**STAFF REPORT**  
**COMMUNITY DEVELOPMENT DEPARTMENT**

HEARING DATE: June 3, 2021  
 TO: Planning & Zoning Commission  
 FROM: Joseph Dodson, Associate Planner  
 208-884-5533  
 SUBJECT: H-2010-0023  
 Gramercy Commons CUP  
 LOCATION: The site is located at 1873, 1925, and 2069 S. Wells Avenue, in the NW ¼ of the NE ¼ of Section 20, Township 3N., Range 1E.

Conditional Use Permit request for a multi-family development consisting of 164 age-restricted units within a multi-story building wrapped around a multi-story parking garage on 5.24 acres of land in the C-G zoning district, by Intermountain Pacific, LLC.

A. Site Plan (dated: 3/23/2021)

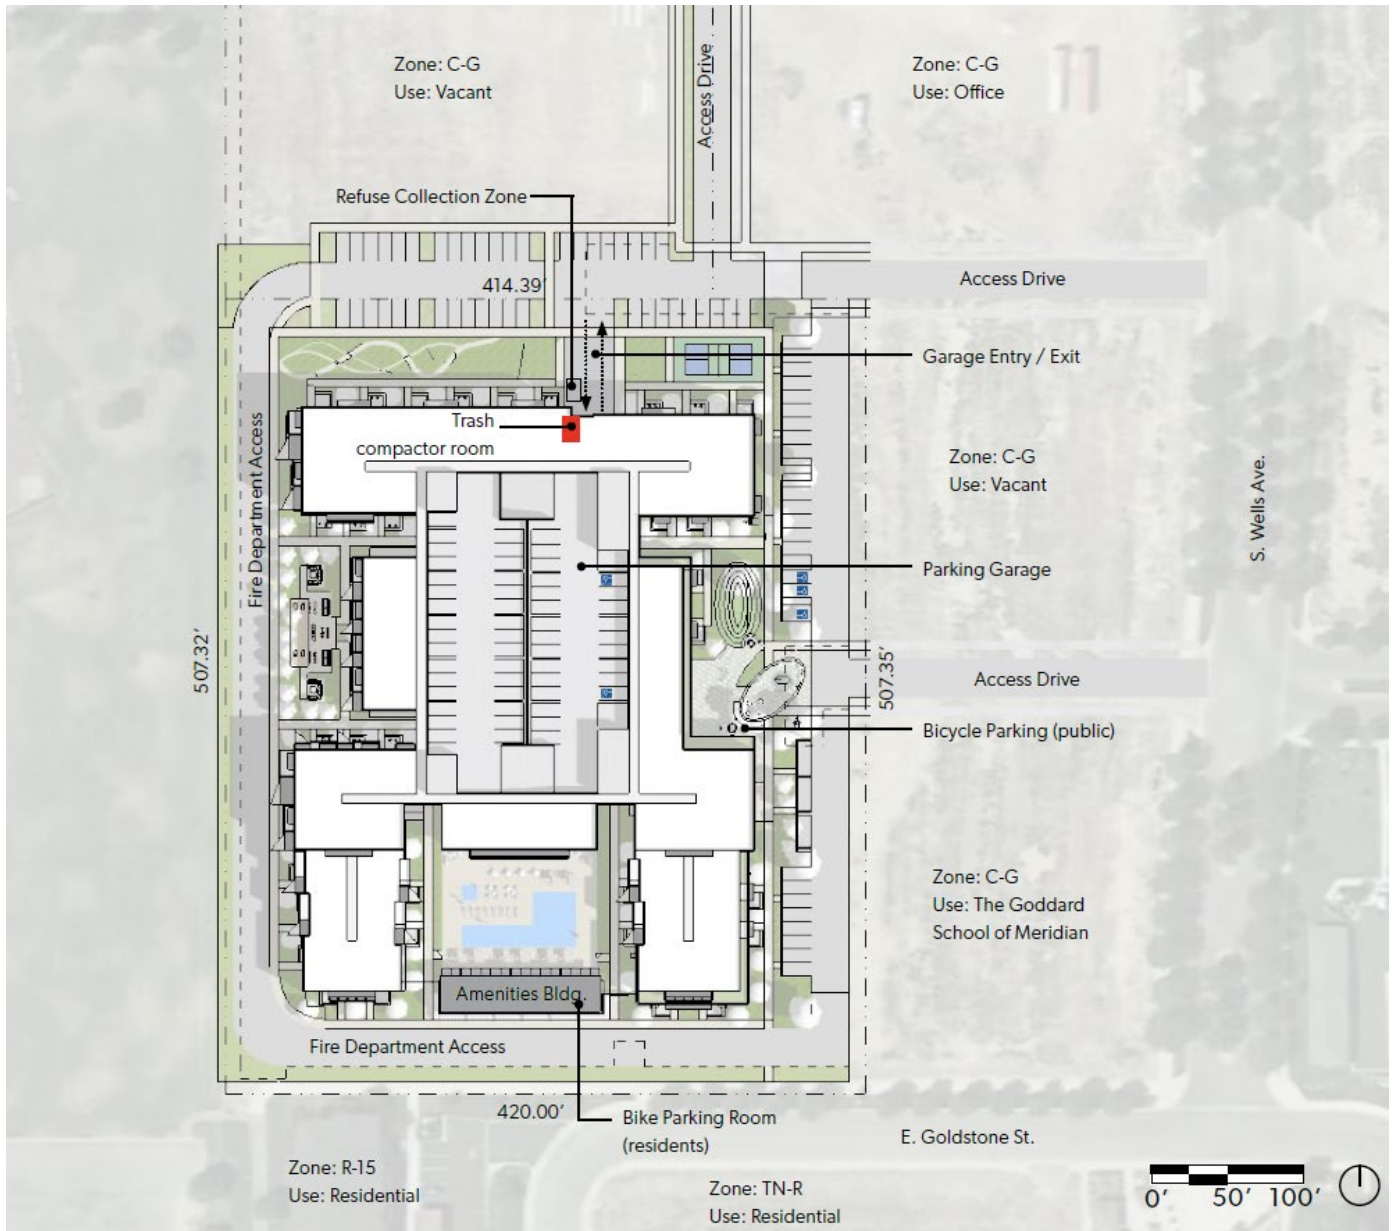
*It is not entirely clear on the submitted plans where these items are contained on-site—where it is not clear, the Applicant shall comply with these requirements at the time of CZC submittal.*

*Despite UDC 11-3A-19B.4 being applicable to nonresidential uses, Staff is recommending the pedestrian crossings from the multi-family building to the multi-use pathway across the emergency drive aisle is clearly delineated from the driving surface by being constructed with either brick, pavers, stamped concrete, or similar. These crossings should be clearly shown on future CZC plans. This point was discussed at the Council hearing for the DA Modification and there is an approved DA provision that requires these connections be constructed in these ways. Staff will verify compliance with a future CZC submittal.*

2. **With the future Certificate of Zoning Compliance submittal, the Applicant shall submit a revised site plan with the following revisions:**
  - a. Depict the pedestrian crossings to the multi-use pathway along the south property boundary to be constructed with bricks, pavers, colored or stamped concrete or similar to clearly delineate the pedestrian walkway.

- b. Clearly depict/label compliance with the Multi-family Development Specific Use Standards (UDC 11-4-3-27), specifically subsection B.7:
    1. A property management office.

2. A maintenance storage area.
    3. A central mailbox location (including provisions for parcel mail) that provide safe pedestrian and/or vehicular access.

4. A directory and map of the development at an entrance or convenient location for those entering the development. (Ord. 18-1773, 4-24-2018)
3. **With the future Certificate of Zoning Compliance submittal, the Applicant shall submit a revised landscape plan with the following revisions:**
